FIRE SAFETY FOLLOW UP INSPECTION

Factory Name	Eve Dress Shirt Limited		Factory ID	11346
Address	Anowar Jung Road, Holding #219, Ward # 05, Block #A, Ashulia, Savar , Ashulia, Savar.			
Initial Inspection Date	31-Mar-2014		Report Received Date	
Date of 1st Follow-up	15-Nov-2015	Date of 2nd Follow-up	21-Mar-2016	
Date of 3rd Follow-up	13-Mar-2017	Date of 4th Follow-up	18-Jun-2017	
Date of 5th Follow-up	28-Sep-2017	Date of 6th Follow-up	14-Nov-2017	
Date of 7th Follow-up	14-Mar-2018	Date of 8th Follow-up	22-May-2018	
Date of 9th Follow-up	05-Mar-2019	Date of 10th Follow-up	06-Sep-2020	
Date of 11th Follow-up	31-Aug-2022	Date of 12th Follow-up		
Date of 13th Follow-up		Date of 14th Follow-up		
Date of 15th Follow-up		Date of 16th Follow-up		
Date of 17th Follow-up		Date of 18th Follow-up		
Date of 19th Follow-up		Date of 20th Follow-up		
Inspected by	Nirmal Chandra Sinha

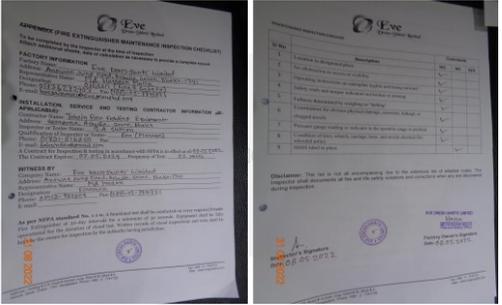
3	There are collapsible doors, rolling shutter & glass swinging doors with locking arrangement at each egress locations.	Replace all non-compliant doors and frames in the means of egress with doors that are listed, approved, automatic-closing, side-swinging, fire rated doors in compatible fire rated frames with latching panic hardware.	Sep 3 2014	<p>On 28/09/2017: Corrected.</p> <p>On 14/11/2017: Corrected</p> <p>On 14/03/2018: Corrected as per previous follow ups.</p> <p>On 22/05/2018: Corrected as per previous follow ups.</p> <p>On 5-3-2019: Corrected.</p> <p>On 06/09/2020 (RSC): Corrected.</p> <p>On 31/08/2022: Corrected. Replaced.</p>	28-Apr-2016	Corrected	Corrected	
4	There are collapsible doors with locking arrangements at each egress locations.	Remove all hasps, locks, slide bolts, or other locking devices at the noted locations.	Jul 9 2014	<p>On 14/11/2017: Corrected</p> <p>On 14/03/2018: Corrected as per previous follow ups. Shall be removed where exist.</p> <p>On 22/05/2018: Corrected as per previous follow ups.</p> <p>On 5-3-2019: Corrected.</p> <p>On 06/09/2020 (RSC): Corrected.</p> <p>On 31/08/2022: Corrected. Removed and not observed during follow-up inspection.</p>	24-Mar-2016	Corrected	Corrected
